ABOUT ADSP-21367 SILICON ANOMALIES

These anomalies represent the currently known differences between revisions of the SHARC ADSP-21367 product(s) and the functionality specified in the ADSP-21367 data sheet(s) and the Hardware Reference book(s).

NR003115G

10. 08000020 - Input Shift Register Anomaly in ASRCs (Asynchronous Sample Rate Converters) impacts Daisy-Chained TDM mode:

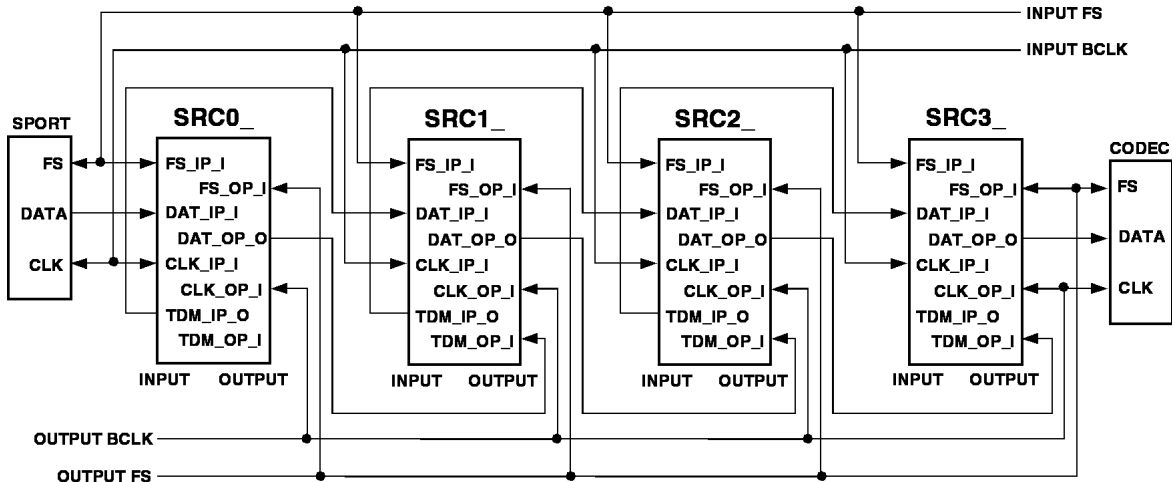
In the TDM Daisy chain mode the ASRCs can be connected as follows to achieve TDM mode:

When the ASRCs are used in TDM Daisy chain mode, the MSB of the input data is lost at the output of each ASRC in the chain. This anomaly is applicable for the TDM mode in both the bypass and non-bypass modes. The following example provides the expected failure pattern for the bypass mode, since in bypass mode the incoming data is not modified by the ASRC.

The workaround for this anomaly must be carried out in software only on the device providing input data to the ASRCs in TDM daisy chain mode. It can not be implemented on the output data from the ASRCs. The workaround implementation in software adds some core MIPS to the application. For devices like ADCs/CODECs, the workaround may not be implemented directly. For such systems, two serial ports of the SHARC should be dedicated for this purpose. One serial port should be used for receiving the data from the ADC/CODEC and the other one should be used for transmitting the modified input data to the ASRC.

When the ASRCs are used in TDM daisy chain mode, only the 24-MSBs of the input 32-bit data is used and the 8-LSBs are not used by the ASRC. The anomaly can be worked around by shifting the 24-MSBs of the data to the 8-LSBs as follows:

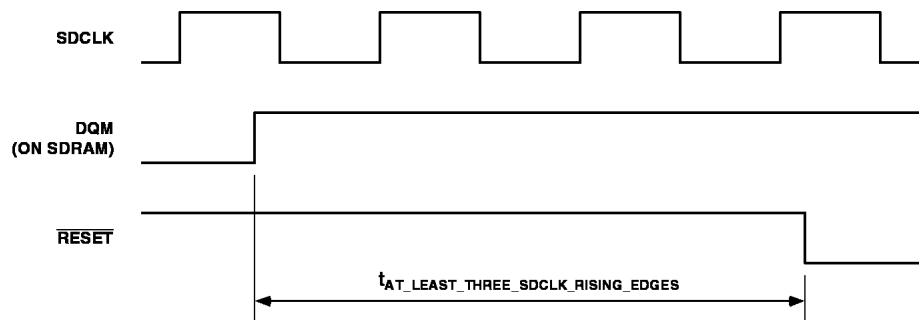
If the SHARC processor is in the process of fetching data from external SDRAM memory, initiating a Hard (hot) reset during this process may cause the SDRAM device to continue to drive the data bus during the entire duration of /RESET being asserted, and also failing to relinquish the external data bus even when the DSP comes out of /RESET.

If the DSP had been configured to boot via parallel external FLASH or EPROM (which shares part of the same data bus with the external SDRAM), the resulting bus contention on the external data bus between the DSP trying to boot from the FLASH memory and the SDRAM continuing to drive the data bus causes incorrect boot data to be loaded in, and the booting operation fails. Once the above state is hit, subsequent DSP Resets will not correct the situation. A power-cycling sequence is required to recover from this state.

Hardware:

Providing an external delay of at least 3 SDCLK clock cycles between the SDRAM's DQM signal and the /RESET_IN to the DSP will also cause the problem to be avoided (see attached Figure).
